ENGINEERING CHANGE ORDER

BOARD NAME <u>TORRENT LCB Mezzanine Baord</u>	ECO# TRNT-008	DATE <u>1/25/2010</u>
BRD SERL# <u>007 ></u>		
PN# _____ REV _____		REV _____
ASBLY# <u>TRNT-EL-04-0003</u> REV <u>A</u>	PCB# <u>TRNT-EL-04-1003</u>	REV <u>A</u>
BOM# _____ REV _____	SCH# <u>TRNT-EL-04-2003</u>	REV <u>A</u>
COGNIZANT ENGNR _____	APPROVD <u>Dee Stover</u>

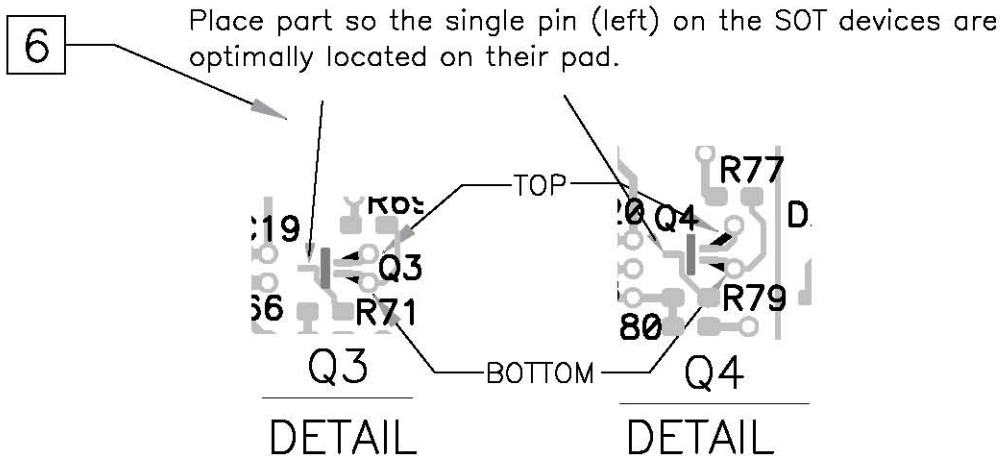
REASON FOR MODIFICATION:
 Q3, Q4 land pattern to small

Use a bare wire, 26–30 awg, to connect from the side with 2 leads (right) to the closest vias. Top pin to nearest top via, bottom pin to nearest bottom via.
